MIXED USE DEVELOPMENT (APPLICATION NO 167.1/2023 PAN-333433
PROPERTY: BROOMFIELD STREET, CABRAMATTA
LANDSCAPE RESPONSES TO COUNCIL LETTER OF 1.12.2023 (COUNCIL RFI'S)

BROOMFIELD STREET CABRAMATTA
PREPARED BY: SITE IMAGE LANDSCAPE ARCHITECTS
ARCHITECT: PLUS ARCHITECTURE
FOR: MOON INVESTMENTS P/L
DATE: 12 FEBRUARY 2024

Future pedestrian bridge, ground floor access

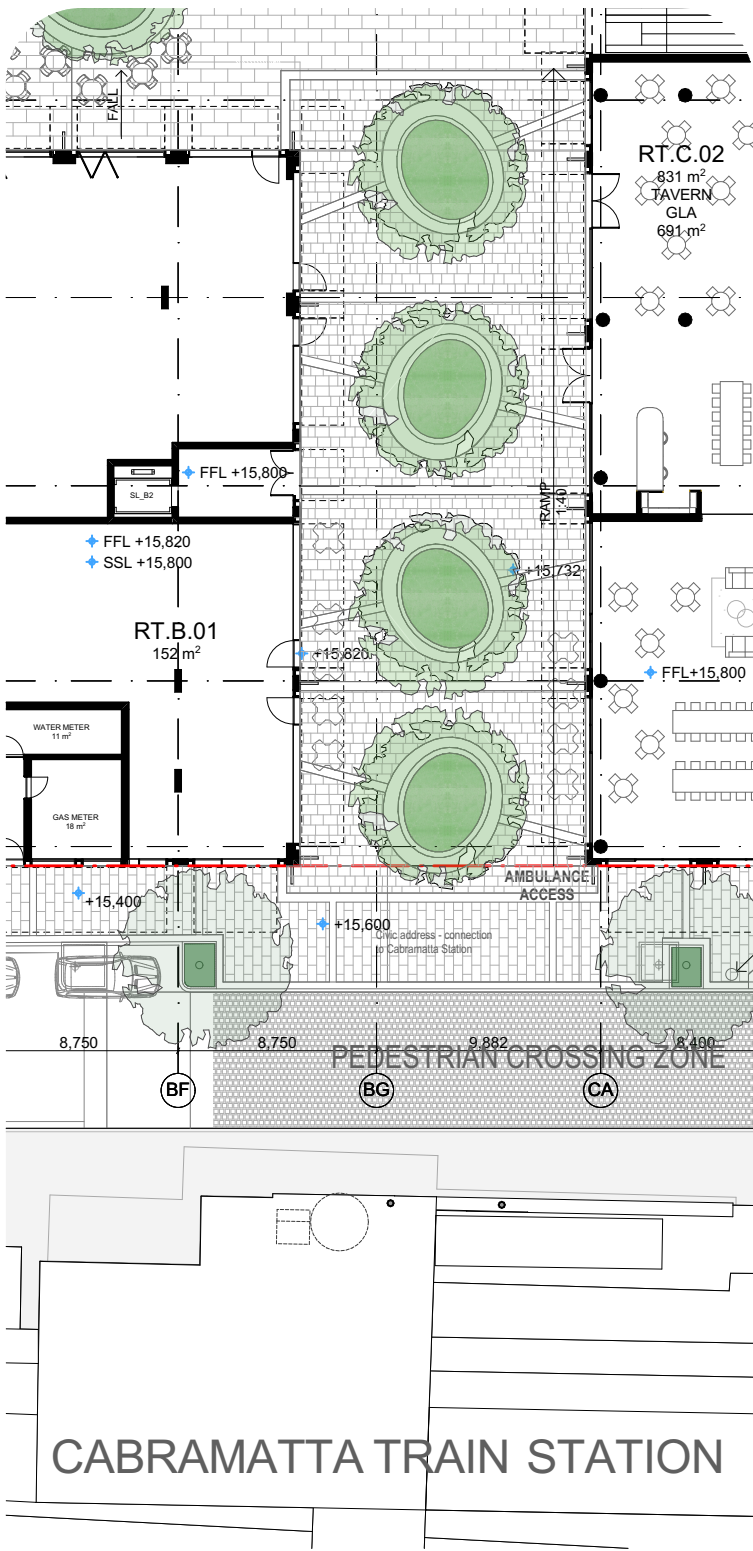
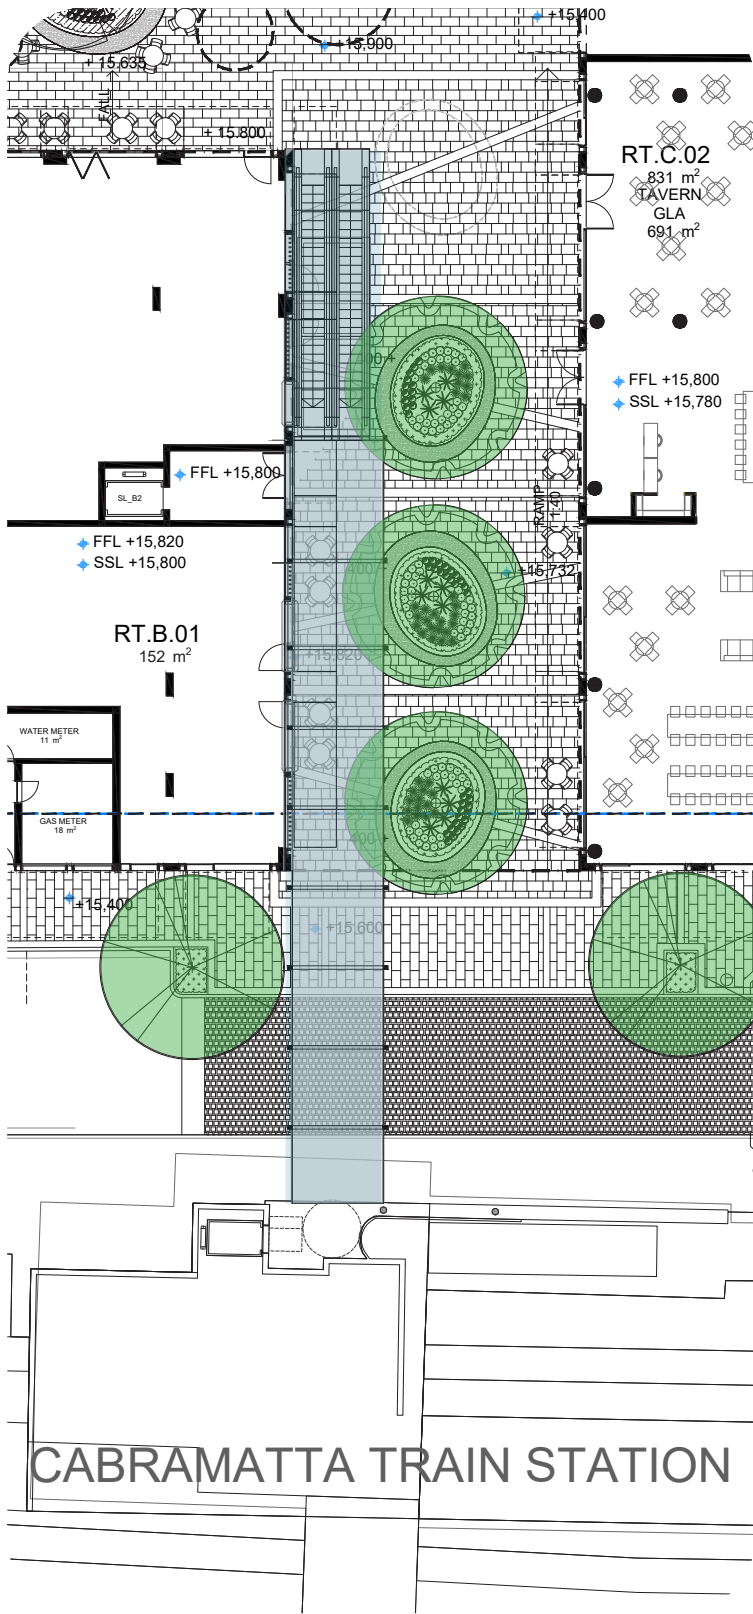
Council Letter 1.12.23 RFI No. 2 - p10 Public domain interface : Future Bridge and plaza entry from Broomfield

The future proposed pedestrian bridge across Broomfield Street has been considered in the site planning and design from close to the outset of the project. The connection directly across from the station level 1 access walkway will allow for seamless movement of pedestrians, with escalators at the eastern end of the link allowing easy access towards and from the main central plaza space. This access point joins directly to the access link space extending from the Broomfield Street frontage into the site. The link space provides easy circulation between retail frontages to the south and north, with oval shaped seating defining raised planters along the space. This allows for easy criss-crossing of the space providing numerous choices to move through the space, with priority for direct east-west along the southern edge. At the ground floor interface with the escalators up to the bridge link, there is some narrowing of the ground floor pedestrian corridor. To ensure an overall equal opening width, one of the four oval seating areas (planters) is removed as part of achieving the bridge link. This creates a generous pedestrian interface with the central plaza space, where there is easy merging of pedestrian moving to / from Broomfield Street, or to / from the Level 1 elevated walkway. The four trees being reduced to three is considered suitable, and not to be a compromise to the general greening of this pedestrian corridor.

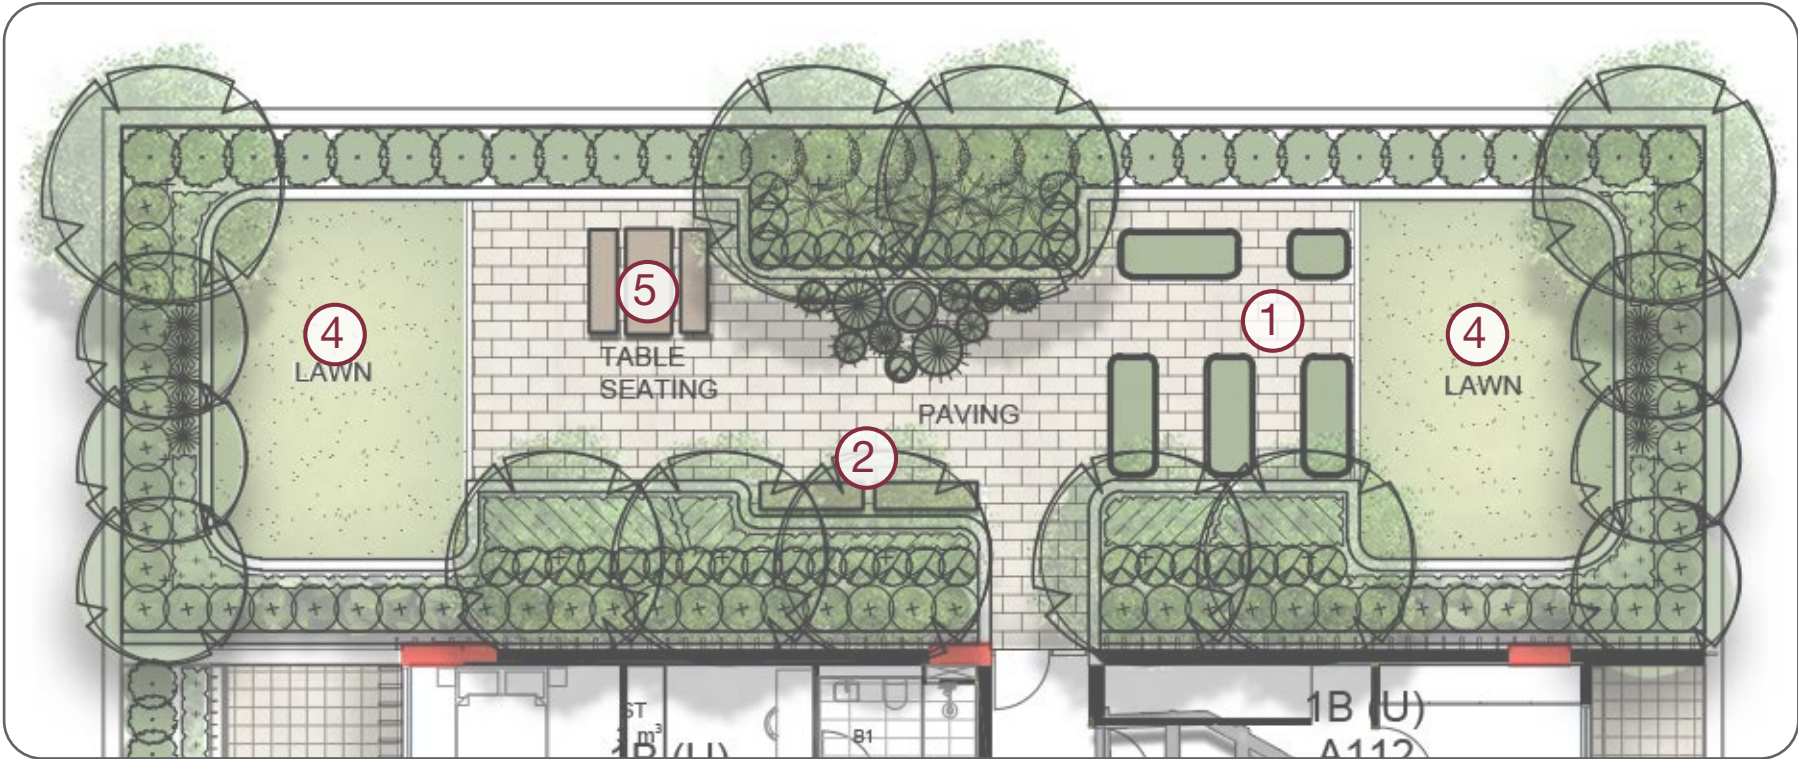
Council Letter 1.12.23 RFI No. 2 - p11 Communal and public open space

BUILDING A - LANDSCAPE. RESPONSE: Building A includes communal open space with complementary / flexible use amenity areas on levels 2, 8 and 15.

Level 2 - West Terrace

The amenity space includes lawn areas for both active and passive use, allied with table settings and community garden beds. A multi program spaces catering for both large and small groups / individuals.

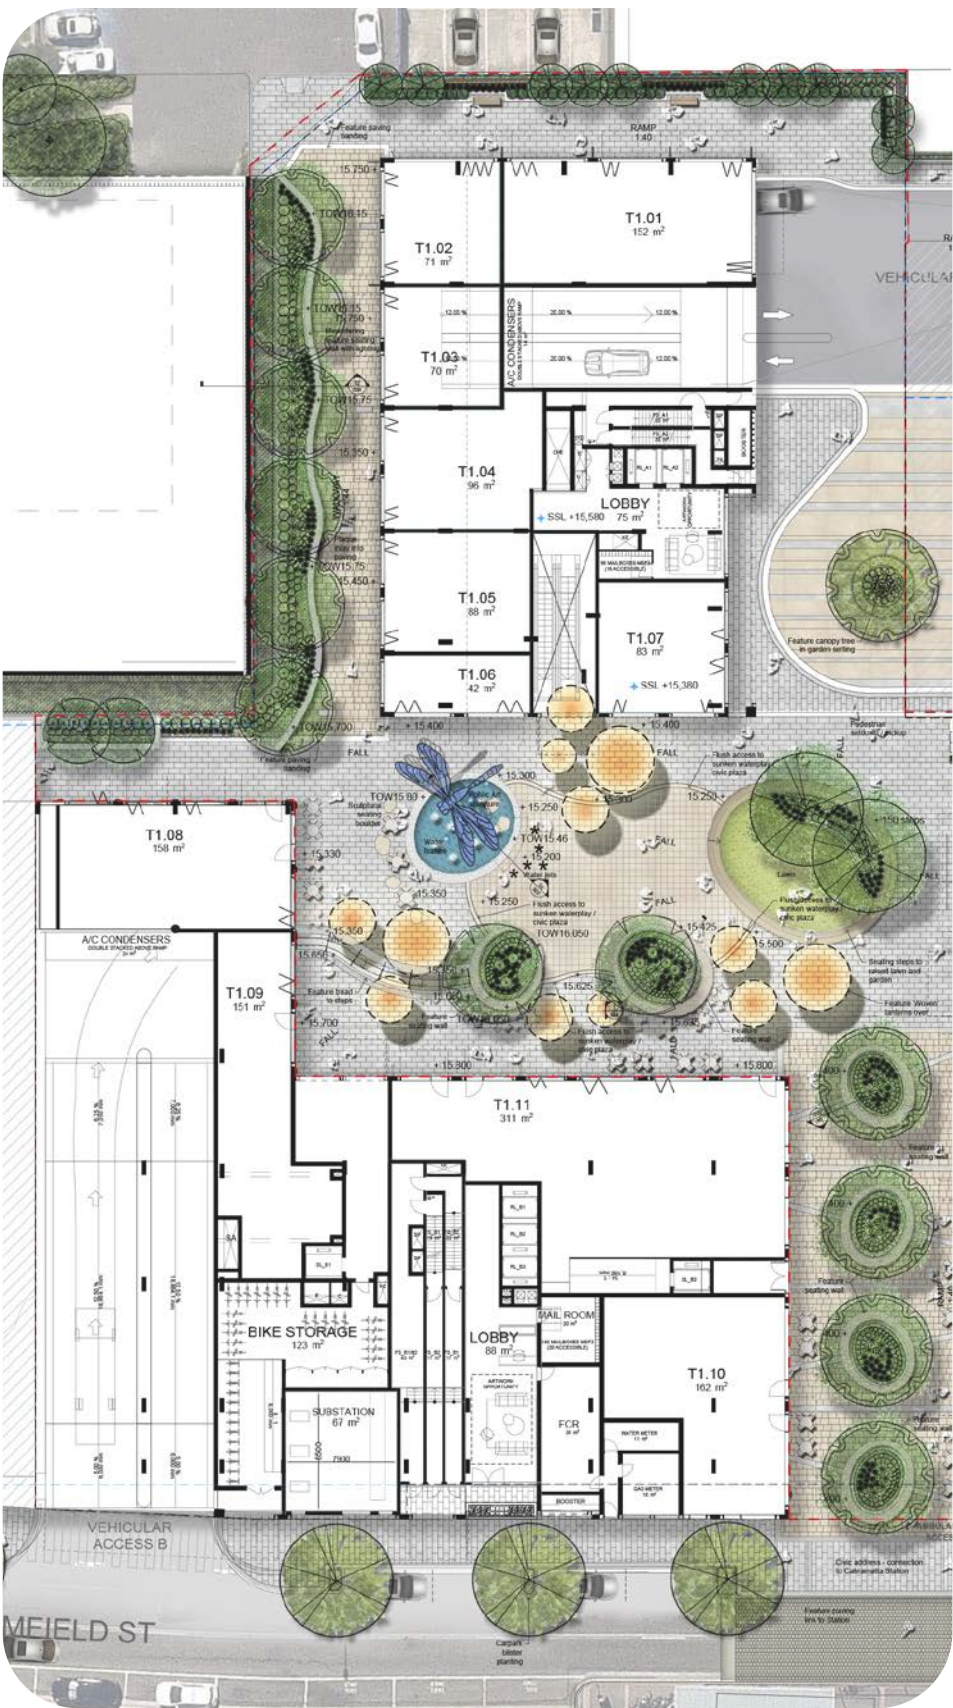
Council Letter 1.12.23 RFI No. 2 - p12 Deep Soil

The site is effectively completely excavated for basements with no deep soil allowances. As such it is expected that substantial soil beds be created within basements and on podiums to deliver equivalent deep spoil outcomes. This is especially important for the plaza, street edges and key primary COS areas on the podium. It is not clear what soil volumes are to be provided in these areas and from inception of the drawings the allowances appear inadequate to sustain the appropriate scale and mix of planting in these areas.

The applicant should investigate a number of deep soil areas of up to 2 metres minimum which may mean adjusting basement carpark to accommodate planting at the plaza level (max planter depth appears to be 1000mm). It is not expected that slab top planters will provide an acceptable outcome. Similarly for the podiums a clear strategy to be described for achieving substantial tree plantings and appropriate soil depths/volumes.

LANDSCAPE. RESPONSE

The site planning of the project has from the outset sought to provide landscape as a feature of the many different civic, retail, seating, walkways and public domain / streetscape spaces. The strong civic and circulation aspects of the various spaces and links has located landscape to complement pedestrian movement and also feature gathering areas. Landscape provides regular tree planting, garden and lawn areas, and vertical greening of edges of ground floor spaces. In discussion with Council the provision of suitable soil volumes to support the intended sizes of feature landscape treatments has been made through generous slab setdowns, raised garden areas, and many locations where setdowns and elevated planting areas provide 1200-1500 soil depths. The outcomes have been presented to various panels and to Council staff, and agreed to suitably support the intended landscape outcomes across the various ground floor and various levels of the buildings.

The request for provision of deep soil, distributed in areas across the site appears to contradict previous discussions with Council. The intensity of retail and activated public open spaces across the site is consistent with the agreed ambition for this site to create a CBD anchor space to the eastern end of the significant retail / commercial precinct of Cabramatta. The addition of residential above has been acknowledged as a strong driver of providing people and activity to contribute the strong destination users and cross site movement across this pivotal site adjacent to the major railway / transport hub. The priority throughout has been to fulfill the landscape design outcomes proposed with suitable soil provisions. There is allied stormwater absorption and peak water flow patterns across the site that acknowledge the benefits of water recharge of deep soil in areas adjoining and near to the site. However, as a CBD site the distribution of Deep Soil across the site contradicts the very common circumstance where civic and public space activation is achieved without tall canopy forest type tree spaces. Suitable medium sized canopy trees are achieved across the site to complement the civic spaces. The significant shaded spaces across the site provide good amenity for users and reduction of urban heat, offsetting the requirement for canopy shade trees that is suited to less intensive retail / civic land uses types.

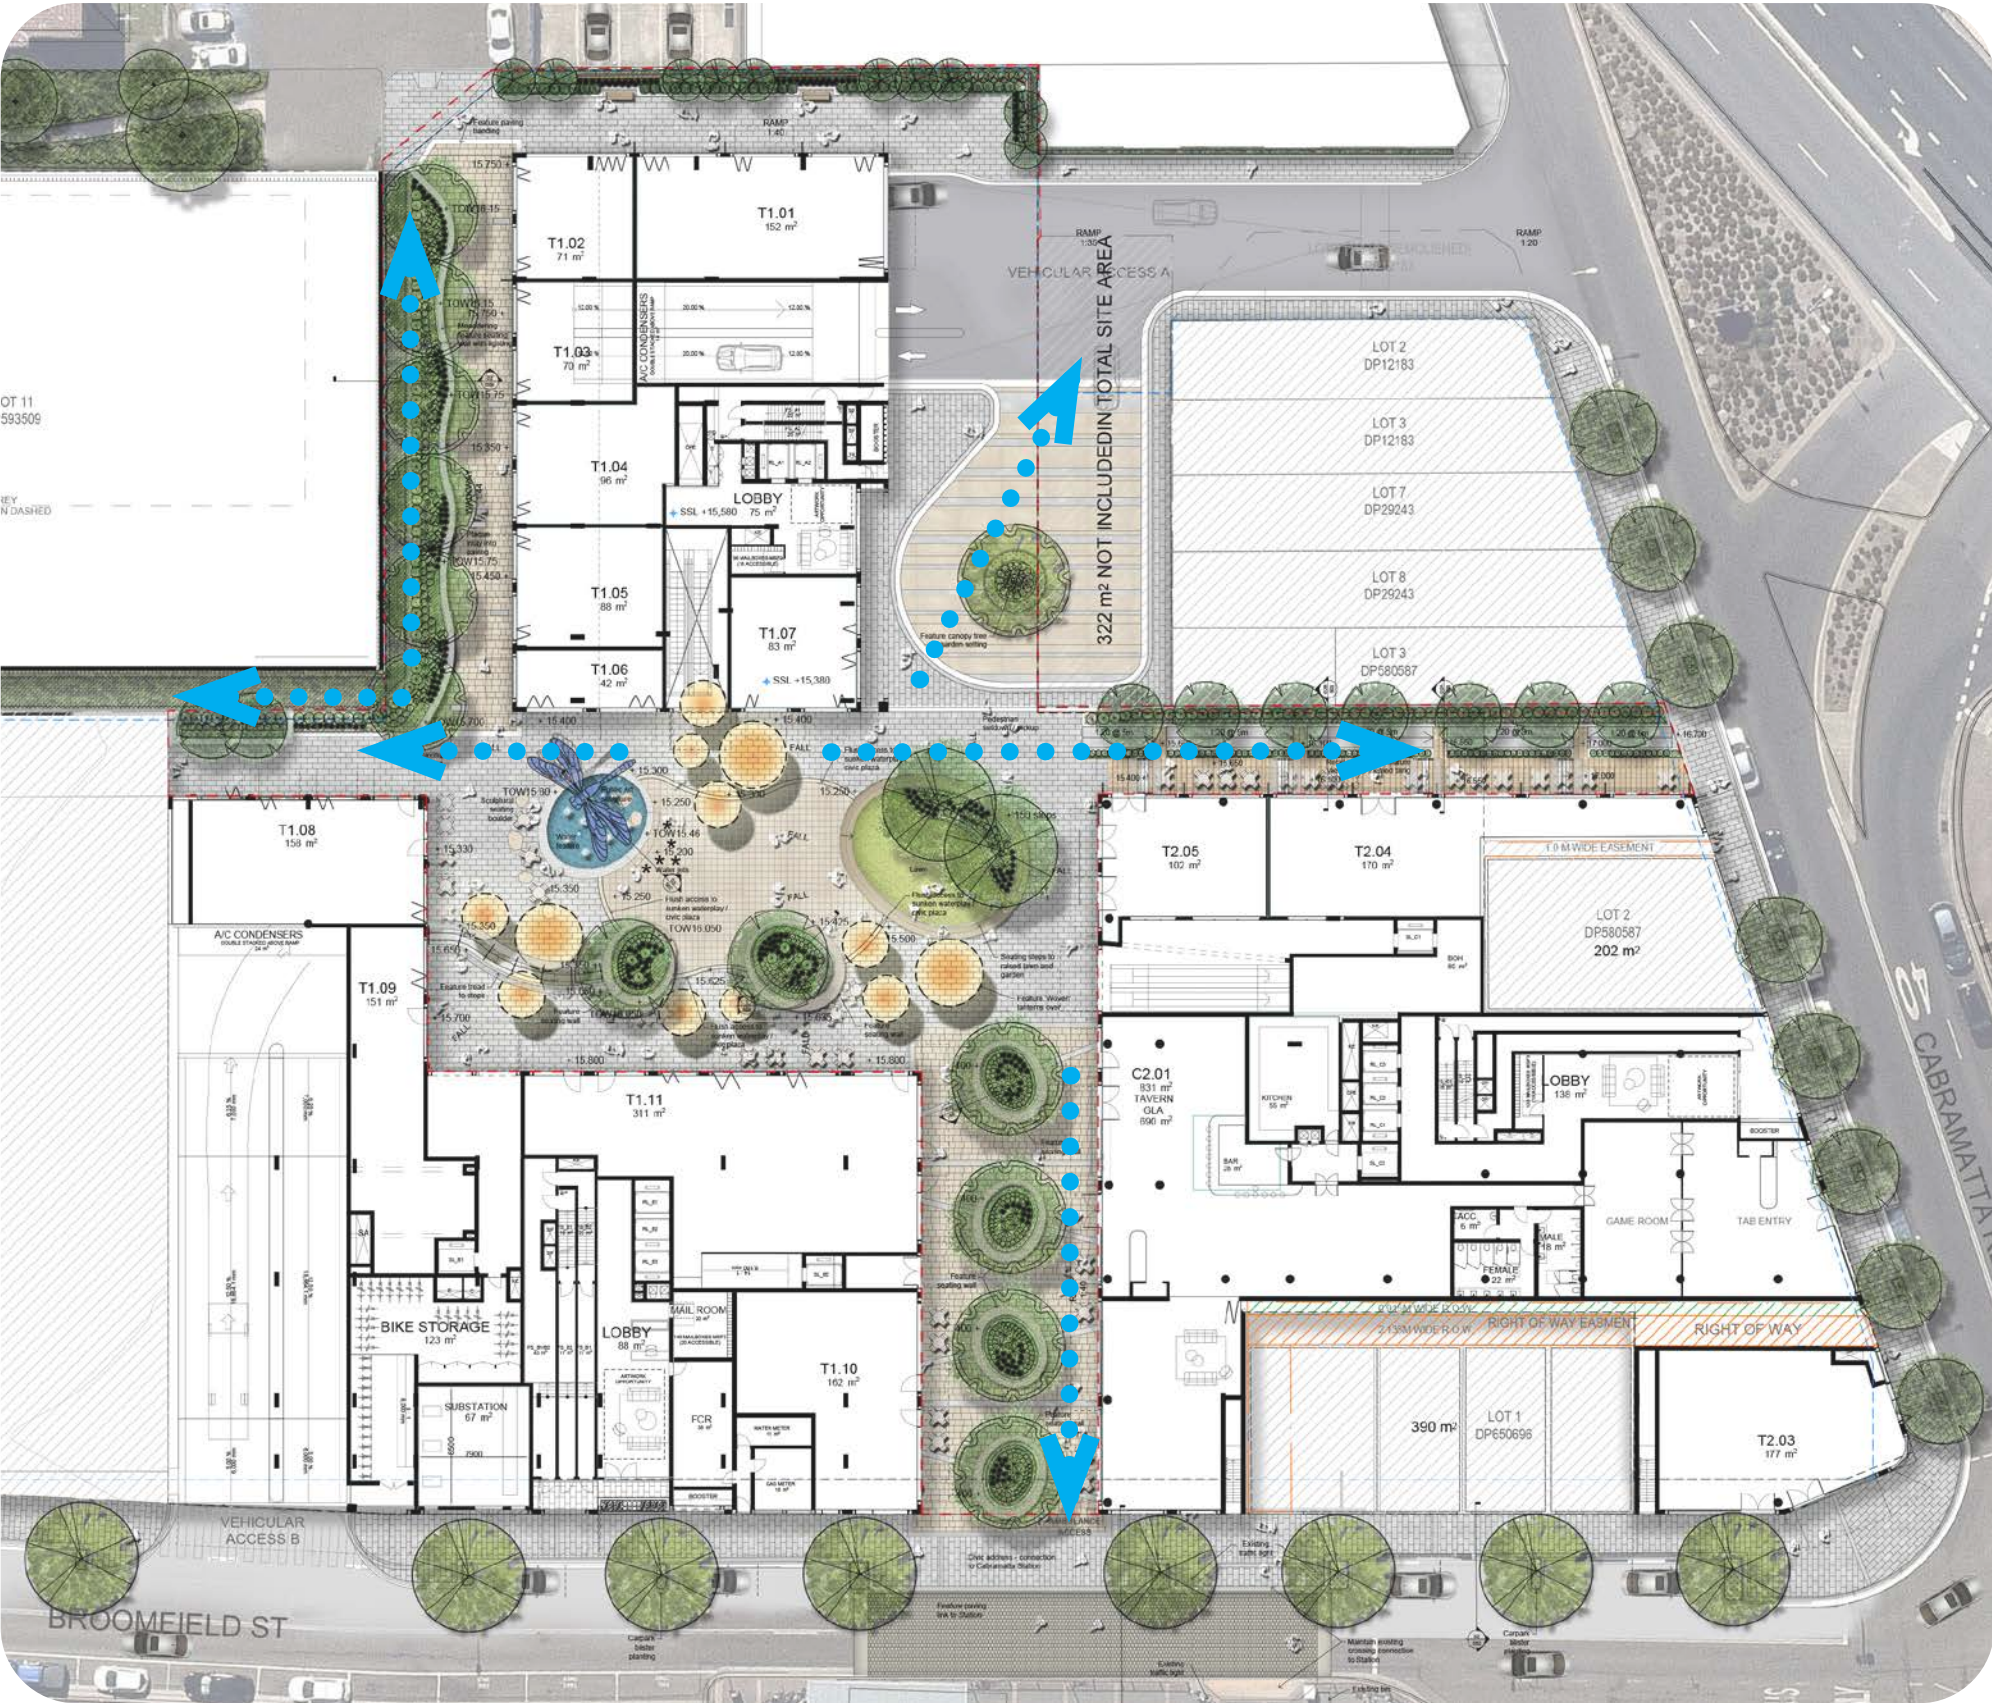
Council Letter 1.12.23 RFI No. 2 - p21 Stormwater and Flooding

1. To ensure proper management of stormwater runoff presenting generated by the laneway, it is necessary to relocate Council’s stormwater asset currently situated within the lot that will be created upon completion of the proposed Subdivision/ Road Closure. A qualified engineer shall prepare Civil Engineering Plans outlining the relocation of Council’s stormwater assets outside the proposed lot boundaries. These plans should also include the extension of the kerb and gutter along the proposed boundary to effectively capture the stormwater runoff from the laneway, considering that the existing pit is the lowest point within the laneway.

The initial analysis of the site highlighted the need for significant consideration of peak water events in the landscape and civic design. There is an understanding that the adjoining streets do flood, and that management of overland water flow is to responsibly direct water away from buildings, basement access points, key civic spaces and other identified risks. Slow release of water from catchment areas is part of downstream flood mitigation, with design assisting the reasonable directing of water to Council agreed water movement paths. The architectural and landscape designs have worked closely with civil and hydraulic engineering consultant team members to achieve outcomes understood to meet the requirements of Council’s Engineers. It is understood there has been a thorough and extended process of consultation, and that proposals were prepared to meet the requirements of Council.
